IMPORTANT SAFETY RECALL 22V-674

SN712

MODELS AFFECTED: TL80, TL80/112, TL100

SUBJECT: Boom Tip Leveling Cylinder Support Boss Weld

Figure 1. Welds to Inspect, Both Sides of Leveling Cylinder

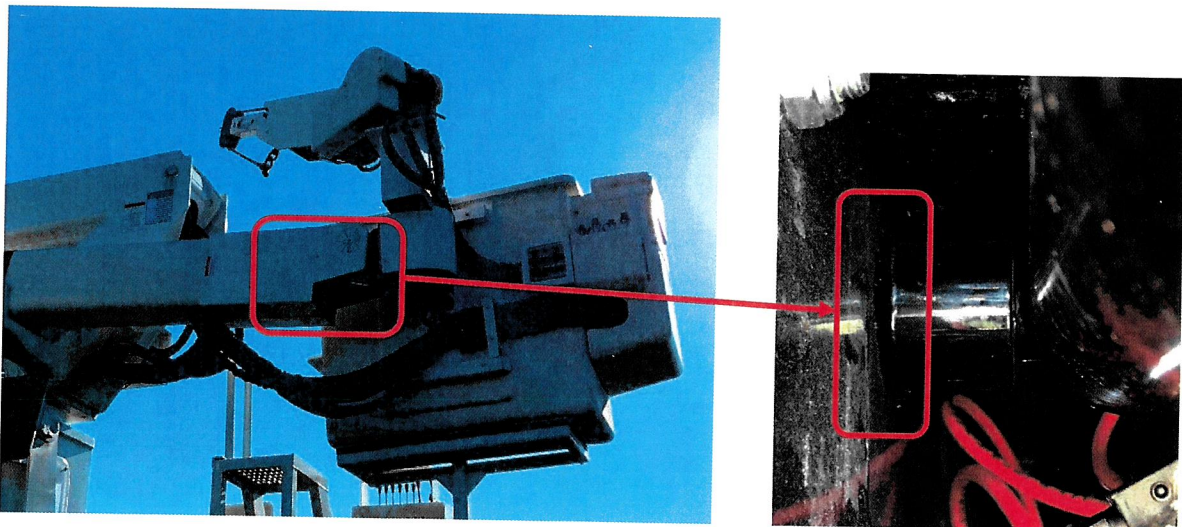
Terex model TL80, TL80/112, and TL100 aerial devices, produced from March 2019 through August 2022, may have the welds for the boom tip leveling cylinder support boss fail. Once the welds fail, the cylinder base pin may flex repeatedly until it cracks, and it may fail. **Failure of the cylinder base pin may result in the platform tipping, causing the platform occupants to fall resulting in injury.**

1. Immediately inform all users, operators, and supervisors of the content of this bulletin.
2. Inspect for cracks of the boom tip leveling cylinder boss to boom welds, using Figure 1 as reference.
 - a. If the welds are not cracked, see the Continued Use section in this bulletin.
 - b. If the welds are cracked, do not use the machine until Field Service Kits Z1665 and Z1666 (TL80/112 only) are installed.

Terex will provide for all TL80, TL80/112, and TL100 machines Field Service Kit Z1665, parts and six (6) hours labor, at no cost to the customer. Field Service Kit Z1665 will add reinforcement plates to the boom tip leveling cylinder bosses inside the upper boom. For all TL80/112 machines, Terex will also provide Field Service Kit Z1666, parts and two (2) hours labor, at no cost to the customer. Field Service Kit Z1666 will add a ratcheting tie down for the hydraulic elevator at the base of the machine.
